Subject: Issuance of Amendment Nos. 164, 164, and 161 to Facility Operating Licenses DPR-38, DPR-47, and DPR-55 - Oconee Nuclear Station, Units 1, 2, and 3 (TAC Nos. 63068, 63069, 63070)

The amendments revise the TSs to raise the reactor protection system high reactor coolant system pressure trip setpoint from 2300 psig to 2355 psig.

AMENDMENT TO FACILITY OPERATING LICENSE

SAFETY EVALUATION BY THE OFFICE OF NUCLEAR REACTOR REGULATION

Figure 2.3-1
Amendment No. 164 (Unit 1)
Amendment No. 164 (Unit 2)
Amendment No. 161 (Unit 3)

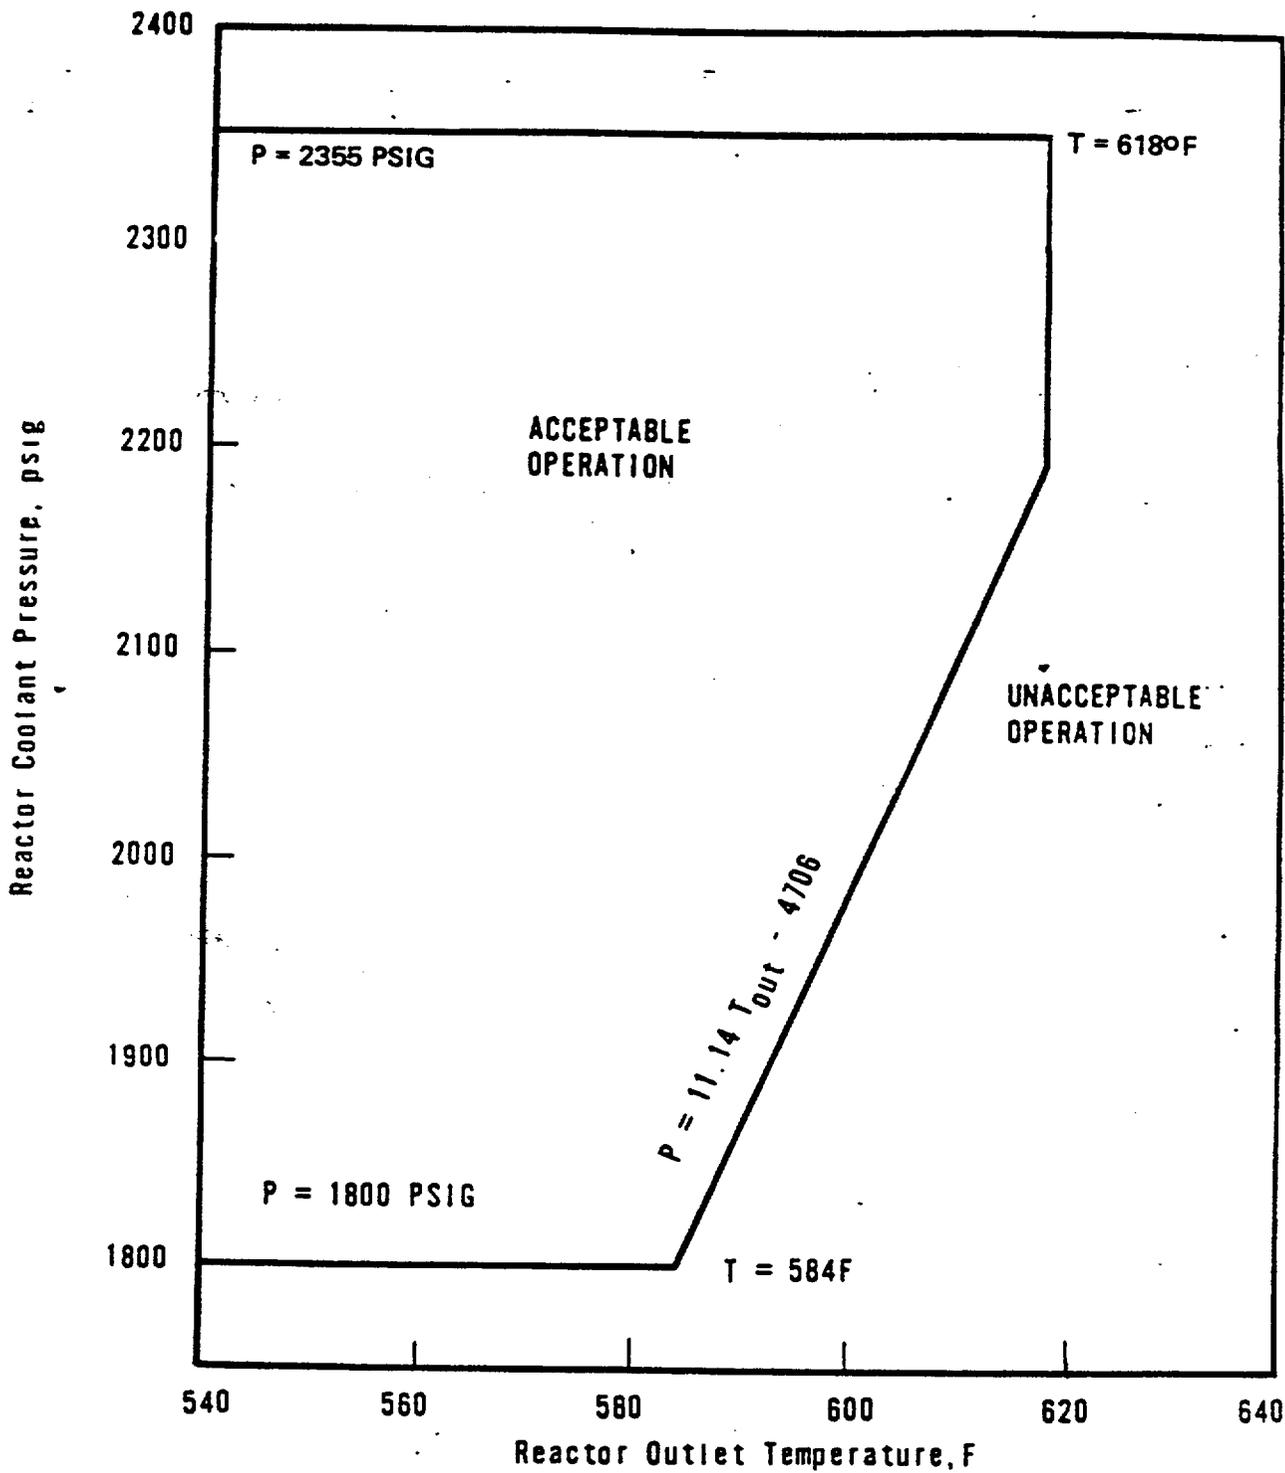
1. TS 2.2 Bases, Page 2.2-1. Safety Limits - Reactor System Pressure. The value of the setting for the reactor high pressure trip is changed from 2,300 psig to 2,355 psig as found acceptable in Section 2 above.
2. TS 2.2 Bases, Page 2.3-3. Reactor Coolant System Pressure. The value of the setting for the reactor high pressure trip setpoint is changed from 2,300 psig to 2,355 psig as found acceptable in Section 2 above.
3. Table 2.3-1 of Reactor Protection System Trip Setting Limits, Page 2.3-7. The value for the high reactor coolant system pressure was changed from 2,300 psig to 2,355 and is acceptable as explained in Section 2 above.
4. Figure 2.3-1 - Protective System Maximum Allowable Setpoints. The reactor coolant pressure was raised from 2,300 psig to 2,355 psig. This is acceptable as explained in Section 2 above.

The staff with assistance from EG&G has reviewed the proposed changes to TS 2.2, Table 2.3-1, and Figure 2.3-1 for Oconee Units 1, 2, and 3. The proposed change would increase the setpoint for trip of the reactor on high pressure in the reactor coolant system from 2,300 psig to 2,355 psig. As discussed in Section 2, the proposed changes meet the NRC positions established in the review of the B&W topical report and, therefore, meet the applicable regulatory guidance and requirements and are, therefore, acceptable.

During a startup accident from low power or a slow rod withdrawal from high power, the reactor coolant system (RCS) high pressure setpoint is reached before the nuclear overpower trip setpoint. The high RCS pressure trip setpoint (2355 psig) ensures that the pressure remains below the safety limit (2750 psig) for any design transient.⁽²⁾ The low pressure (1800 psig) and variable low pressure ($11.14 T_{out} - 4706$) trip setpoints shown in Figure 2.3-1 ensure that the minimum DNBR is greater than or equal to the minimum allowable DNBR for those accidents that result in a reduction in pressure.^(3,4) The limits shown in Figure 2.3-1 bound the pressure-temperature curves calculated for 4, 3, and 2 pump operation.
